Monticello Nuclear Generating Plant  
2807 W County Road 75  
Monticello, MN 55362

Monticello Nuclear Generating Plant Completion of Required Action by NRC Order EA-12-051 Reliable Spent Fuel Pool Instrumentation (TAC No. MF0924)

### **Monticello Nuclear Generating Plant Completion of Required Action by NRC Order EA-12-051 Reliable Spent Fuel Pool Instrumentation**

#### **Responses to Requests for Additional Information**

**Figure 1 - 1 – Spent Fuel Pool Levels**

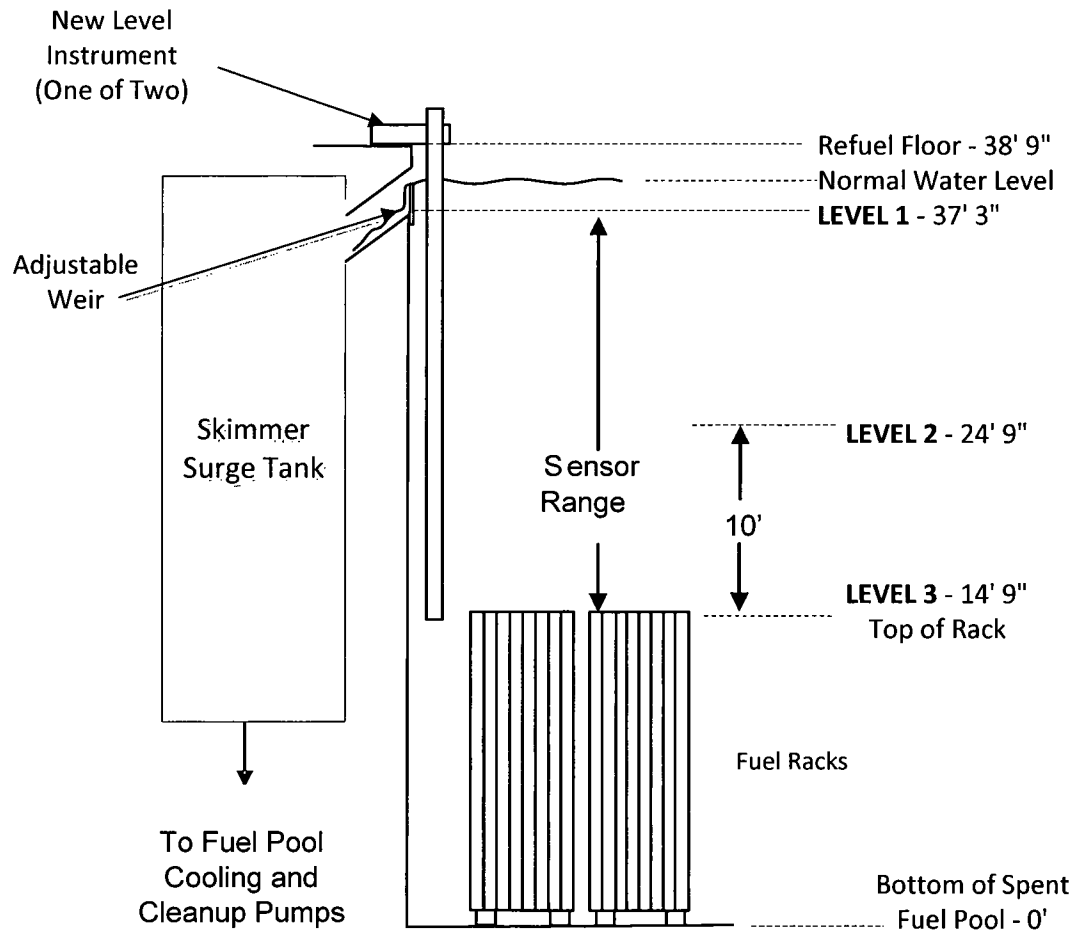
*Given the potential for varied dose rates from hardware stored in the SFP, please provide a description of how the elevation identified as Level 2 might be affected.*

For the MNGP Spent Fuel Pool, pool levels are defined in Figure 1 - 1 provided below:

NSPM performed a calculation of the dose rates in the spent fuel pool at various levels in accordance with NEI 12-02. The results of the calculation indicated that the total integrated dose for the dielectric material is  $9.79E+08$  rad. The instrument material is qualified for a total dose of 10 Grad, or  $1.0E+10$  rad. Therefore, the qualified radiation dose for the material is greater than the calculated results and is acceptable.
